# Access Compliance Report

## Public Rights-of-Way

### (Curb Ramps)

Intersection ID: 23415	Main Street: ENGLISH_MEADOWS_LN	Cross Street: OLD_PROVIDENCE_RD	Location: NW
ADA ID: C46EA7DE4A5A	Ramp Type: PerpDiag	Initial Pass/Fail: Fail	Overall Compliance: No
		Severity Score: 12.5

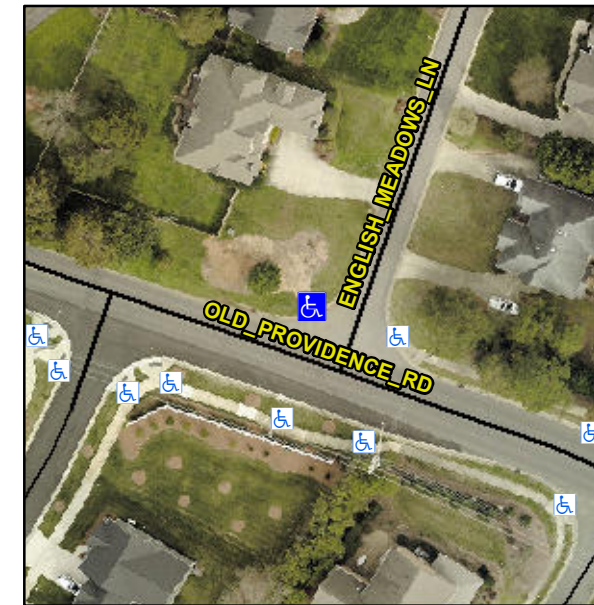
**Not Found, R304.2.2**

Compliance	Description	Data	Compliance	Description	Data
N/A	Ramp Length (in)	59.5	No	Ramp Slope (%)	8.6
Yes	Ramp Width (in)	48.0	Yes	Ramp XSlope (%)	1.8
N/A	Flare Type LT	N/A	N/A	Flare Type RT	N/A
N/A	Flare Slope LT (%)	N/A	N/A	Flare Slope RT (%)	N/A
N/A	Flare Traversable LT?	N/A	N/A	Flare Traversable RT?	N/A
N/A	Landing Length (in)	N/A	N/A	DWS Provided?	N/A
N/A	Landing Width (in)	N/A	N/A	DWS Contrast?	N/A
N/A	Landing Slope (%)	N/A	N/A	DWS Length (in)	N/A
N/A	Landing X Slope (%)	N/A	N/A	DWS Full Width?	N/A
N/A	Landing Curb? (Y/N)	N/A	N/A	DWS Offset (in)	N/A
N/A	Shared Landing?	N/A			
N/A	Gutter Ponding?	N/A	N/A	Gutter Slope (%)	N/A
N/A	Gutter Lip Ht (in)	N/A	N/A	Gutter X Slope (%)	N/A
N/A	Painted X Walk1?	No	N/A	Painted X Walk2?	No
	X Walk 1 Direction	To SE		X Walk 2 Direction	To SW
N/A	X Walk 1 Width (in)	N/A	N/A	X Walk 2 Width (in)	N/A
	X Walk 1 Slope (%)	0.3		X Walk 2 Slope (%)	0.6
	X Walk 1 X Slope (%)	1.5		X Walk 2 X Slope (%)	0.9

**Remove & Replace Curb Ramp With Two New Directional Ramps or Equivalent.**
